Loss of throttle actuation in trucks with EDC, CAG and Scania retarder

Background

Before modification

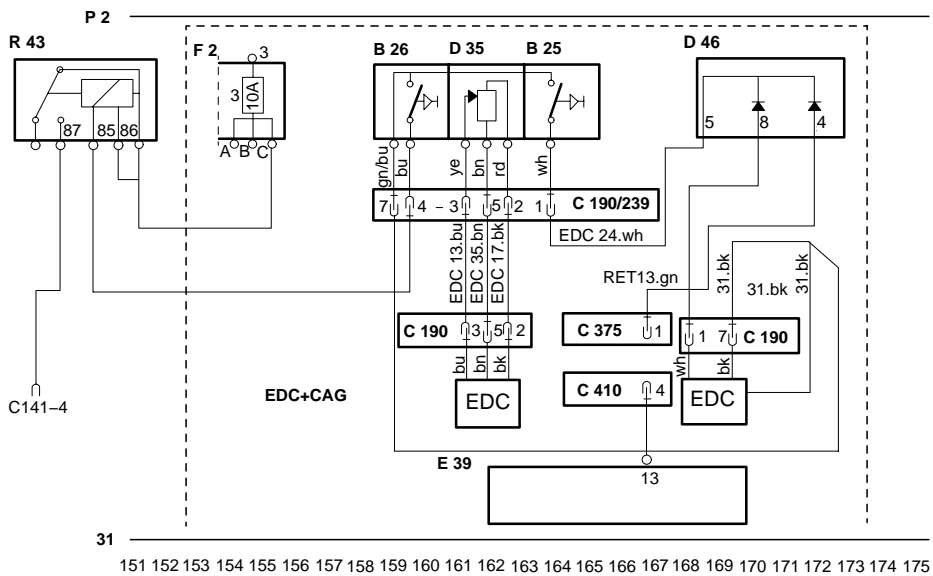
In order to remedy this problem, relay R43 should be replaced with a diode unit. The throttle pedal sensor must be changed at the same time.

4. Remove relay R43 from its relay holder.
5. Do the following the relay holder where the diode unit will be located:
 - Switch cables RET13.gn (previously R4387B) and EDC 24.wh (previously R43-86) with each other.

- Cable EDC24.wh (previously R43-87) is left in place.
 - Detach and insulate both twin-strand cables 31.bk (previously R43-30 and R43-85). These must not be cut off.

- **Note:** As there are two white cables are marked EDC24, it is important to move the correct one.
6. Fit diode unit D46 in the relay holder.
7. Fit a new relay, R43, part number 243 460, and a new relay holder in the central electric unit.

8. Fit a new cable between fuse 3 (pin C) in fuse holder F2 and R43-30. Detach and insulate the existing cable.
9. Fit a new cable between R43-30 and R43-86.

10. Cut the cable between C190/239-4 and C141-4. Connect cable C190/239-4 to R43-85 and cable C141-4 to R43-87.
11. Cut off cable EB.bu from connector C190/239-7 and connect it to cable 31.bk from C190-7.
Note that there are three cables to this terminal.
